**REPORT ON DELIVERABLE WP2.3
APERTURE ARRAY CONCEPT DESIGN REVIEW**

Document number MGT-005.010.020-MR-004
 Revision 2
 Author A.J.J. van Es
 Date 2011-06-30
 Status Approved for release

SKA APERTURE ARRAY CONCEPT DESIGN REVIEW

Figure 1 (Figure 9 of SEMP): Reviews, baselines and phases at each Element level of the SKA project.

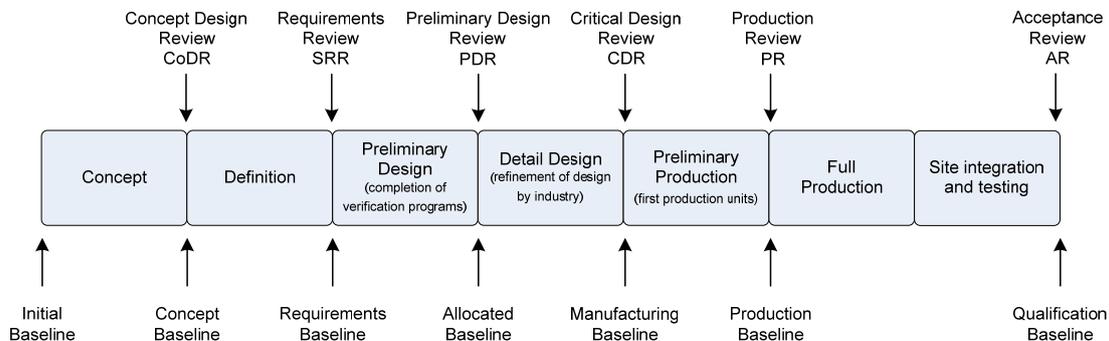
Note that a linear process operating in isolation, such as implied by Figure 1, is an over simplification. A much more complex process is expected: simultaneous development of system requirements, element requirements, cost and performance data will necessitate an iterative approach and frequent interaction with the system design.

The panel believes the expected goal has been reached: a concept baseline has now been established for AA-low, using the project accepted definitions (see Figure 1 and [1]). However, more work is needed in the near term to bring different aspects of this baseline up to a common level of maturity, which is necessary for a balanced assessment and robust analysis supporting elimination of options in the next phase.

Figure 2: A simplified version of Figure 16 of the System High Level Description [3].

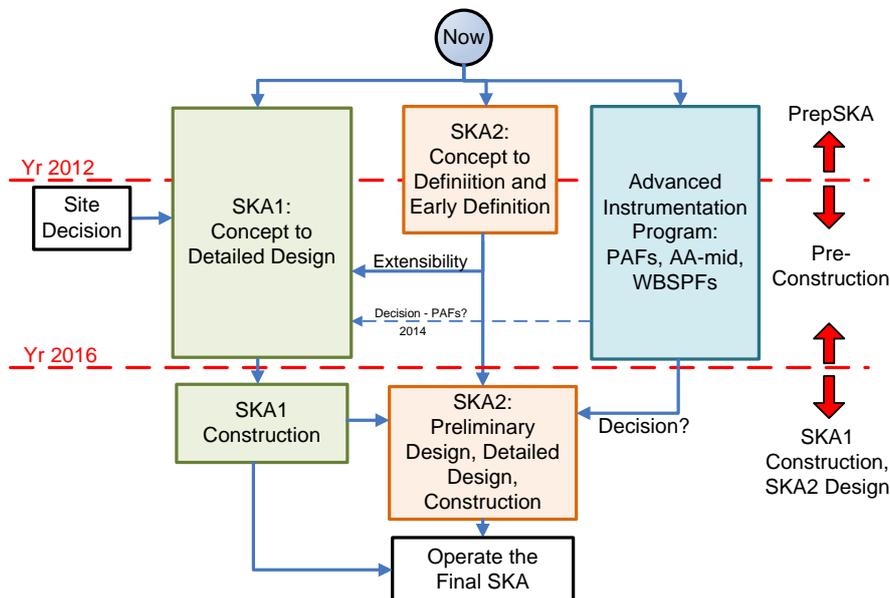
Development of AA-mid requirements will require further investigation of SKA2 science and system requirements. This investigation is commensurate with the SKA project workflow illustrated in Figure 2.
